SIZE	CODE IDENT NO.		REV
D	DSUV8	B64-13020	C
BLEED AIR ECU ASSY/INSTALL		SHEET 1A OF 9

<input checked="" type="checkbox"/> ECO <input type="checkbox"/> ECR	NO. 4809	EFF DATE OF CHG 13 AUG. 1996	REQUESTED BY Ray Morrison	PREMIER	PAGE 1 OF
REASON FOR CHANGE ADD ALTERNATE LOCATION		DOCUMENTS AFFECTED Blot-13020	SYSTEM	MATERIAL DISPOSITION	
MARKED PRINTS ATTACHED YES <input type="checkbox"/> NO <input checked="" type="checkbox"/>		SERIAL NO EFF	REWORK	STORE	IN MFG.
			SCRAP		
			USE AS IS

<input checked="" type="checkbox"/> ECO <input type="checkbox"/> ECR	NO. 4716	EFF DATE OF CHG 04 APR. 96	REQUESTED BY JEFF J.	PREMIER	PAGE 1 OF 1
REASON FOR CHANGE ADMINISTRATIVE		DOCUMENTS AFFECTED B64-13020	SYSTEM BLEED AIR ECU	MATL DISPOSITION	
MARKED PRINTS ATTACHED YES <input type="checkbox"/> NO <input checked="" type="checkbox"/>			SERIAL NO EFF	REWORK	STORE IN MFG.
				SCRAP	
				USE AS IS

<input checked="" type="checkbox"/> ECO <input type="checkbox"/> ECR	NO. 4413	EFF DATE OF CHG 6 JAN 95	REQUESTED BY ECR 788	PREMIER	PAGE <u>1</u> OF <u>1</u>
REASON FOR CHANGE DRAWING ERROR		DOCUMENTS EFFECTED B64-13020	SYSTEM BLEED AIR ECU ASSY/INSTL	MATL DISPOSITION	
MARKED PRINTS ATTACHED YES <input ty

SIZE	CODE IDENT NO.	
D	OSUV8	B64-13020
		REV C
BLEED AIR ECU ASSY/INSTALL		
SHEET 2 OF 9

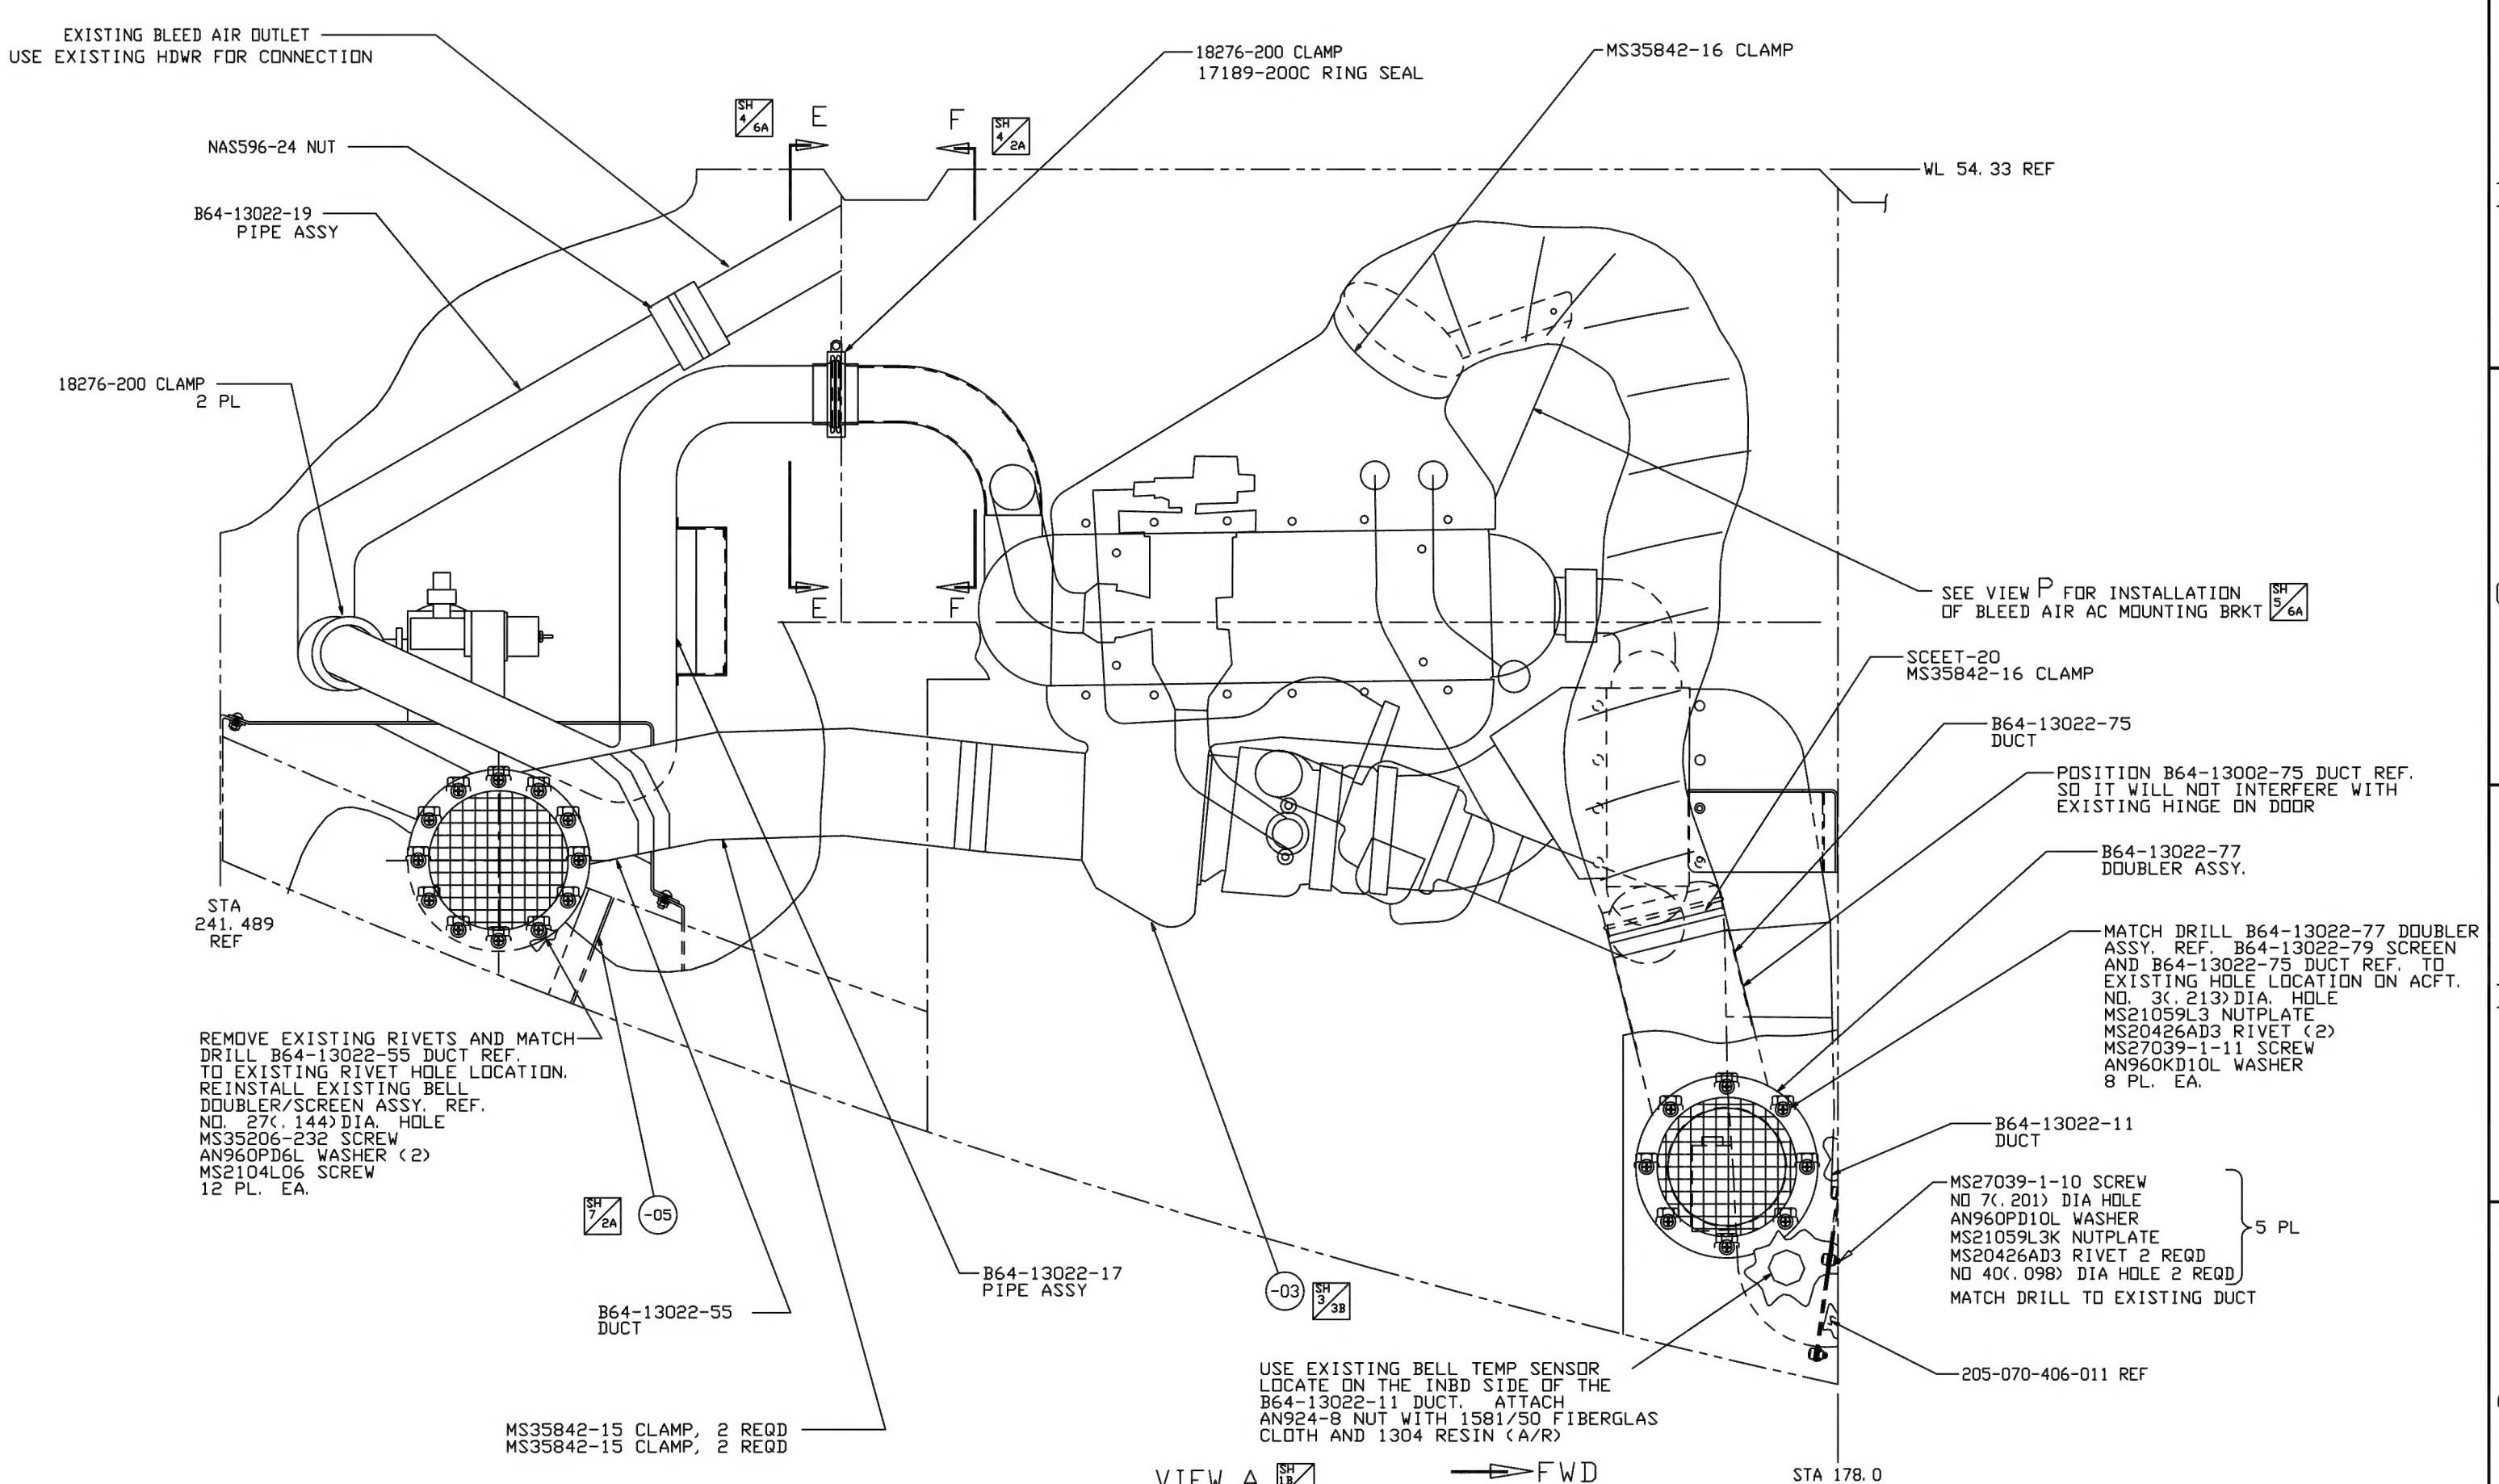
SHEET 2

"CHANGED" CALLOUT ZONE 8C
 "WAS" 18276-200 CLAMP, 2 PL
 "IS" 24540-200 CLAMP, 2 PL
 "CHANGED" CALLOUT ZONE 4D
 "WAS" 18276-200 CLAMP, 17189-200C RING SEAL
 "IS" 24502-200 CLAMP, 17189-200C RING SEAL

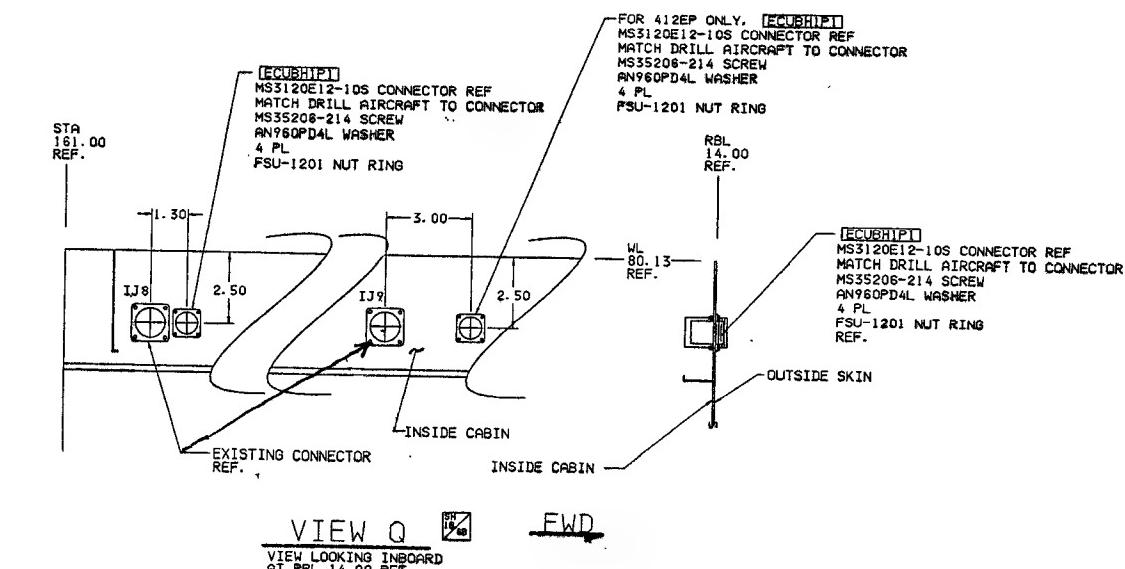
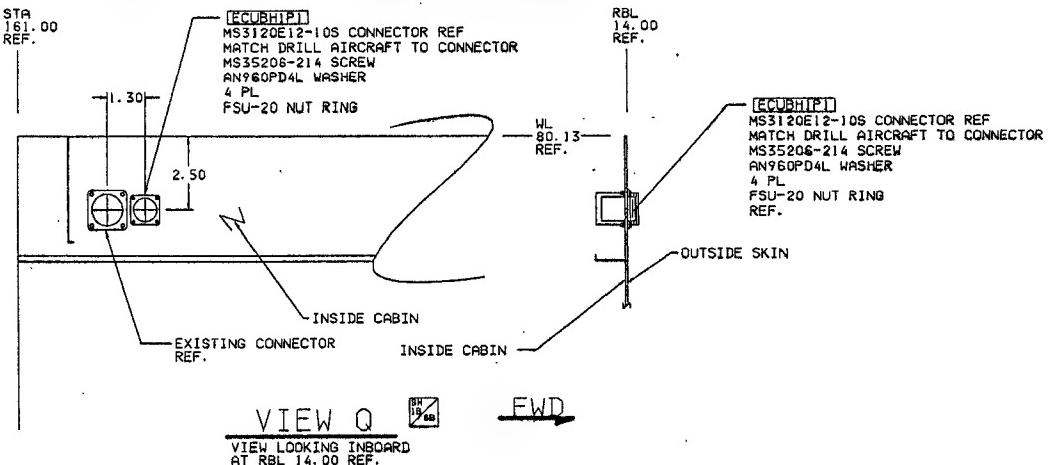
DESCRIPTION

SH 8443 : DETAIL & CALLOUT
